Grants Reclamation Project

RE: HMC Response to NRC's "Request for Additional Information, Final Status Survey and Disposition Survey Report for Piping Materials," Docket No. 040-08903, License No. SUA-1471, EA-16-114

**HMC Responses to RAI from NRC: FSS of Land Application Areas and
Disposition Survey Report for Piping Materials**

Figure 1: Distribution of measured Th-230 concentrations in groundwater supply wells for the northern irrigation areas (top) and southern irrigation areas (bottom).

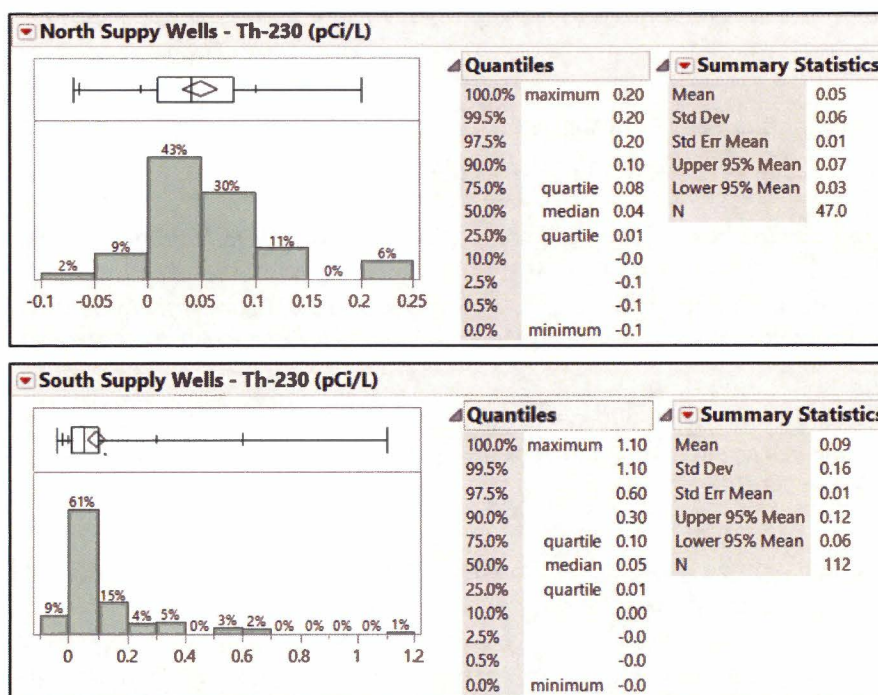
RAI No. 6: Please provide additional information on the determination that Th-230 was not found in applied irrigation water at levels significantly different than background in local groundwater. Please include any potential impact from any individual well(s) exceeding background Th-230 values.

HMC Response: The word "significantly" was not intended in a statistical sense as statistical comparisons with Th-230 concentrations in local background groundwater aquifers have not been performed. However, summary statistics for available Th-230 groundwater monitoring data for the irrigation supply wells (Figure 1) show low concentrations that are generally comparable to an average, population-weighted background level for groundwater in the U.S. of 0.04 pCi/L as cited in the Toxicological Profile for Thorium (ATSDR, 2019).

While the average Th-230 concentration in the south supply wells is about twice the national average background value cited above, the average is highly skewed by a few individual high measurements, the median is consistent with the national average background value, and all recorded levels are still low, well below the World Health Organization's (WHO) Guideline Level for Th-230 in drinking water [1 Bq/L (27 pCi/L)] (WHO, 2008). The WHO Guideline Levels for radionuclides in drinking water are based on a dose limit of 0.1 mSv/yr (10 mrem/yr) and were derived using dose conversion factors from the International Commission on Radiological Protection (ICRP) Publication 60 (ICRP, 1990). In addition, all recorded values in the northern irrigation supply wells, and 90% of all recorded Th-230 values from the south irrigation supply wells, are below the Site's groundwater quality standard of 0.3 pCi/L for Th-230 as specified in LC 35(B).
